Site Plan Review Committee (SPRC)
Staff Report for
1400 Richmond Highway (Americana Hotel)
SPLN22-00004

1400 Richmond Highway (SPLN22-00004)
Americana Hotel
(RPC #35-001-002, -003)

**SITE PLAN REVIEW COMMITTEE
MEETING AGENDA**

Figure 18. Sector Plan Design Guidelines: Buildable Envelope and Massing Strategies

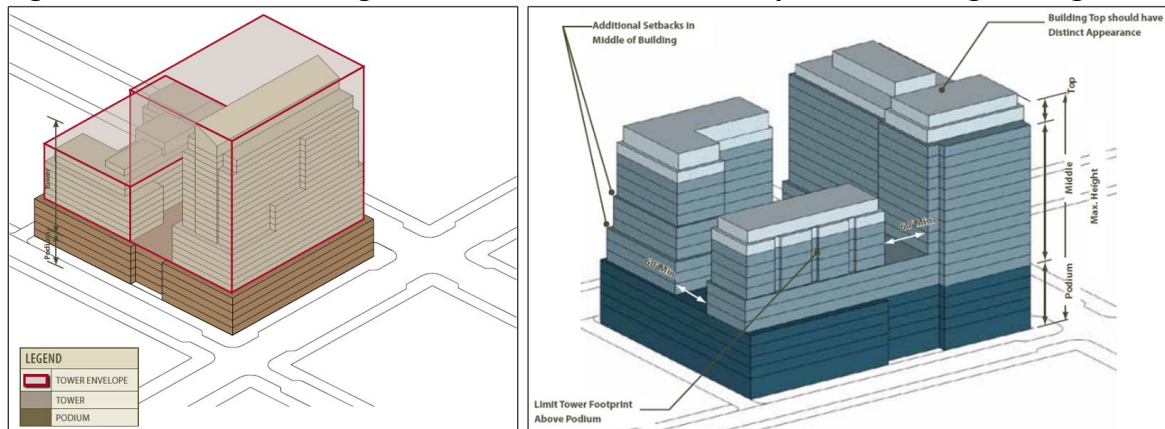
- Building Height:
 - Maximum Allowable Height: The Sector Plan recommends the combined height of the podium and tower not exceed 200 ft for this site. The proposed height meets this recommendation, with a main roof height of 200 ft.
- Podiums:

- **Minimum Frontage Requirements:** The Sector Plan recommends that all podiums should engage the Recommended Build-to Line (RBL) within 0 to 2 ft for a minimum of 80% of the street frontage, and that no portion of the podium façade should be located greater than 10 ft from the RBL. The proposed podium deviates from this recommendation. On South Eads Street, the podium façade engages the RBL for approximately 50% of the street frontage and also includes a portion recessed approximately 49.8 ft from the RBL. Staff acknowledges the site is long and narrow which contributes to a limited frontage on South Eads Street. As a result, meeting the 80% minimum may be challenging to achieve while accommodating both the proposed driveway and east-west pathway. As demonstrated in the Sector Plan, the intended RBL on Richmond Highway is 80 feet from the future street centerline assuming the realignment. As a result, engaging the RBL is not currently achievable since the RBL lies within the existing southbound Richmond Highway off-ramp. However, the future street centerline may shift as a result of the future design and the Richmond Highway RBL may potentially line up better with the building's eastern podium façade as proposed.

- **Required Building Frontage:** The Sector Plan recommends that every building should have at least 1 podium frontage on an RBL for a minimum of 65 ft along the RBL. The proposed podium meets this recommendation, with a podium frontage of 65 ft on the South Eads Street RBL.

- **Podium Height:** The Sector Plan recommends that the maximum height of any podium should not exceed 65 ft. The proposed podium meets this recommendation, with a podium height of 18 ft.

- Towers:
 - Tower Separation: The Sector Plan recommends that towers maintain a minimum separation of 60 ft above the podium base from all adjacent towers. The proposed tower meets this recommendation.

- Tower Coverage: The Sector Plan recommends that building tower coverage not to exceed 65% for the subject site. The proposed tower meets this recommendation, with a tower coverage of approximately 52.7%.

- Forming Towers: The Sector Plan recommends that tower massing should allow light, air, and views to penetrate and through blocks. For uses other than commercial office uses, tower floor plate sizes above the podium base should generally not exceed: 40,000 sf up to 250 ft of height; or 30,000 sf above 250 ft of height. The proposed tower meets this recommendation, with a tower floor plate of approximately 28,614 sf.

- Building Tops: The Sector Plan recommends that a distinctive top, consisting of the upper two to four floors of a tower, should be provided through a change in at least 2 of the following features: window rhythm, apparent floor height, setbacks, sculpted form, or materials. The proposed building top meets this recommendation.

- Mechanical Penthouse: The Sector Plan recommends that the walls of all penthouse structures should be setback from the edge of the roof a distance no less than the height of the wall. All penthouse structures should have enhanced façade treatments of a quality and character consistent with the building's tower façade. One proposed mechanical penthouse structure deviates from this recommendation, with it not set back on the southern roof edge. However, the mechanical penthouse structure is screened with enhanced façade treatments that integrate with the building's tower façade and is sufficiently setback from the east and west roof edges, which line the major street frontages

- **Building Setback Profiles:** The Sector Plan recommends 2 approaches for achieving aesthetically interesting and attractive towers: a Multiple Setback Approach and a Single Setback Approach. While the podium should continuously engage the RBL and meet the back of the sidewalk, the tower massing above should taper or step back from the podium along streets and open spaces to better define the street space for the pedestrian experience and provide architecturally interesting buildings. For building tops, it is generally recommended that the upper 2 to 4 floors of all buildings should be no closer than 20 ft from the RBL, unless the proposed design of the building top involves a dramatically creative architectural treatment that is integral to the overall composition of the building. The initial proposed included only minimal or partial (0 to 5 ft) setbacks above the podium along major street frontages. However, the current proposal includes 5 to 8 ft setbacks above the podium. Staff will continue to evaluate this during the public review process to ensure consistency with the Sector Plan.

Figure 20: Proposed Elevations

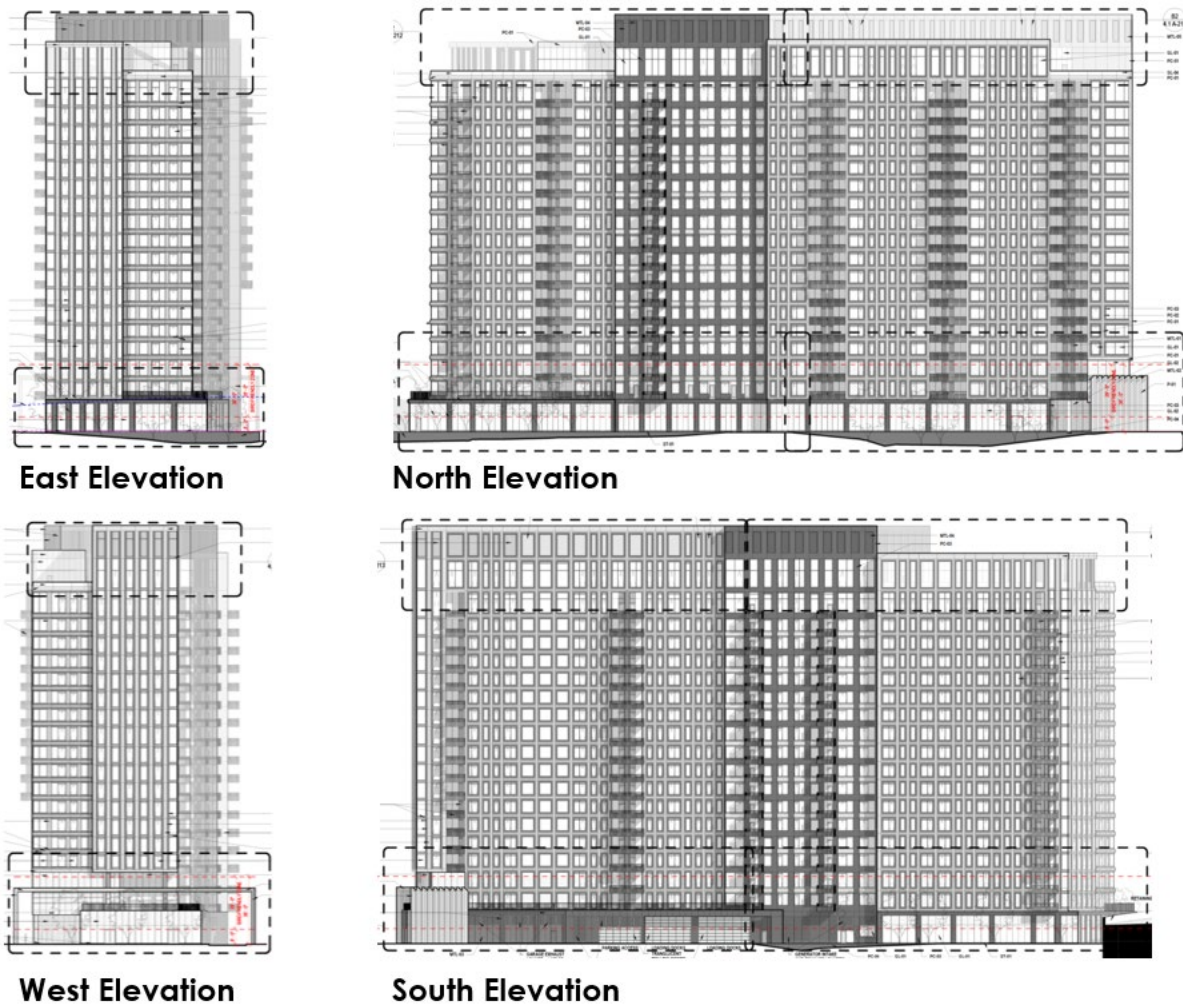
Architecturally, the building is long and narrow (approximately 395.3 ft long and 90.8 ft wide) and follows the dimensions of the property. To avoid a flat and rectilinear façade, the building is

angled slightly in 2 places. The podium consists of a single floor, 18 ft in height, and is comprised of dark gray metal and pre-cast concrete panels. The building tower is comprised of light and dark gray metal and pre-cast concrete panels, with each building face consisting of uniform fenestration. Each floor is approximately 9.7 ft in height and the north and south facades include balconies with metal railings. The building top consists of the 19th floor, 16.8 ft in height, as well as mechanical penthouse screening, 15.1 ft in height. The building top is comprised of light and dark gray metal and pre-cast concrete panels. The South Eads Street building frontage incorporates a 30-foot, metal-cladded canopy structure that spans the street frontage.

Figure 23. Proposed South Eads Street Cross-section

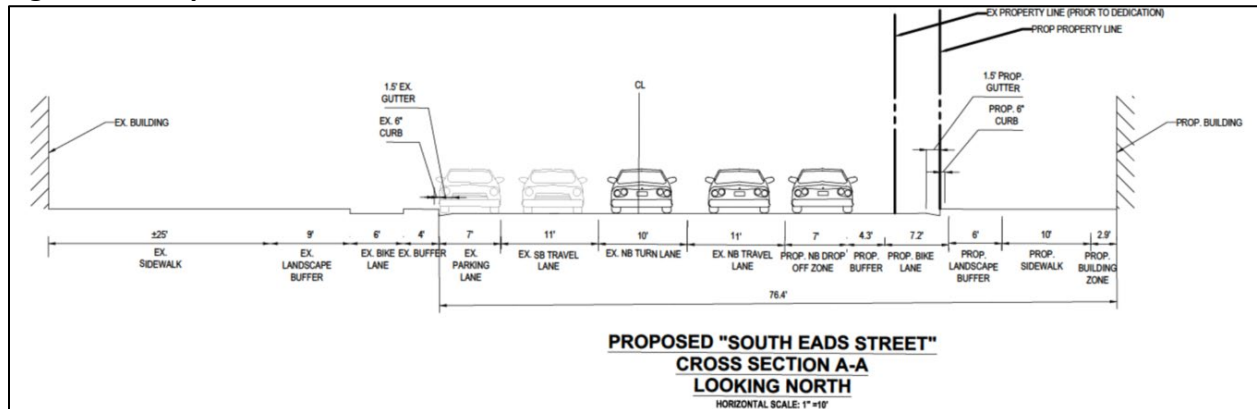
South Eads Street: The site is bounded by South Eads Street to the west, which is being designed in accordance with the County's [South Eads Street Complete Street](#) project to create a safer, more accessible and more comfortable environment for all users. The project will add physical protection to the existing bicycle lane, reconstruct and realign sidewalks, install street lighting and make necessary utility modifications and upgrades along the northbound side of South Eads Street between 12th Street South and 15th Street South. The southbound side of the street will receive improvements as part of Amazon's HQ2 at Metropolitan Park development. The curb-to-curb street width will be approximately 57 ft and consist of 2 travel lanes and 1 turn lane, as well as a parking lane on the west side and protected bike lanes separated by raised medians in each direction. The Americana Hotel streetscape will consist of a 10-foot sidewalk, 6-foot landscaped buffer and an approximate 2.9-foot shy zone. The MTP identifies this section of South Eads Street as a Type-B Primarily Urban Mixed-Use arterial, which

recommends a 6 to 12-foot sidewalk and a 6-foot furniture zone/tree pits. The Sector Plan recommends an 18 to 22-foot sidewalk, including a 6 to 7-foot furniture zone/tree pits.

Figure 24. Proposed Richmond Highway (Existing) Cross-section

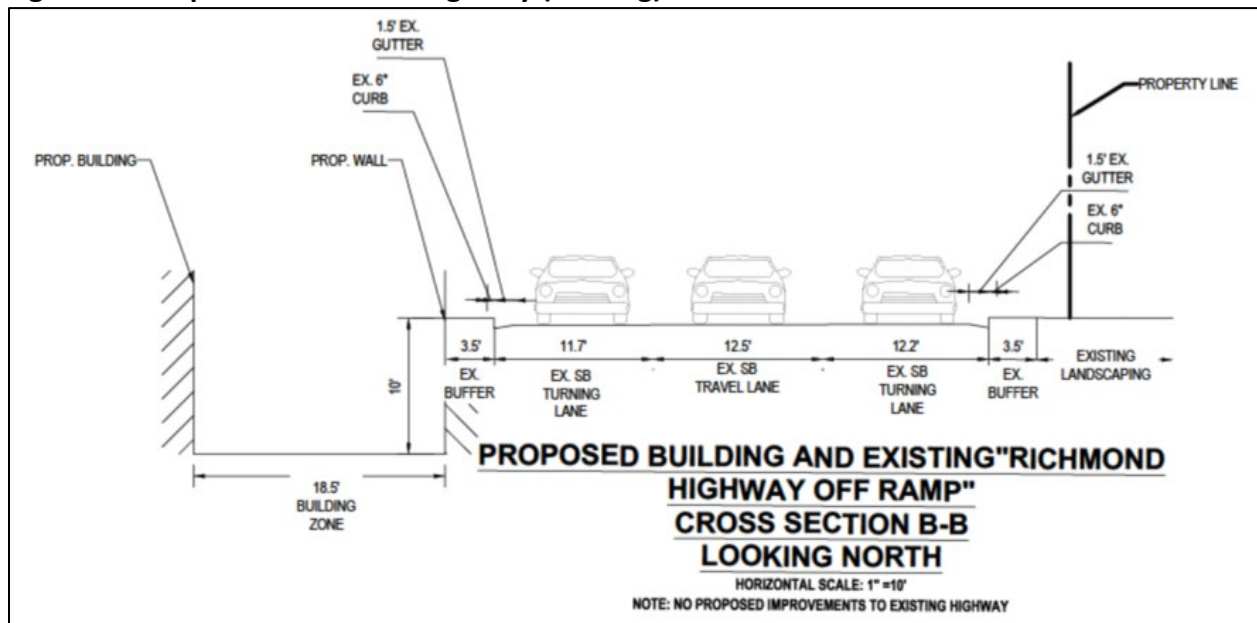
Richmond Highway (Existing): The site is bounded by the Richmond Highway elevated off ramp to the east, which consists of 3 southbound lanes. While there is no existing sidewalk, there is an approximate 18-foot buffer between the building face and the off ramp retaining wall.

Figure 25. Proposed Richmond Highway (Future) Cross-section

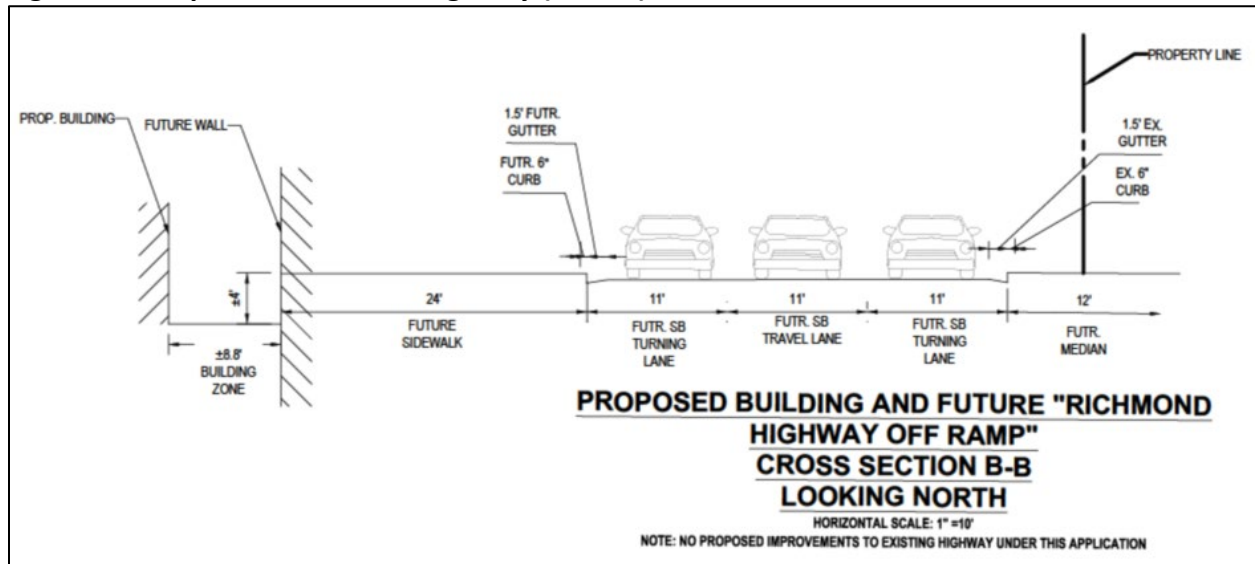
Richmond Highway (Future): Based on the schematic streetscape designs of the future at-grade configuration of Richmond Highway provided by VDOT, the west side of Richmond Highway will consist of a 24-foot sidewalk and a small buffer between the building face and the sidewalk. The MTP identifies Richmond Highway as a Type-F Primarily Low to Medium Density Mixed-Use arterial, which recommends a 6-foot sidewalk or 10-foot shared-use path and at least an 8-foot

green strip. The Sector Plan recommends an 18 to 25-foot sidewalk, including an 8 to 10-foot furniture zone/tree pits.
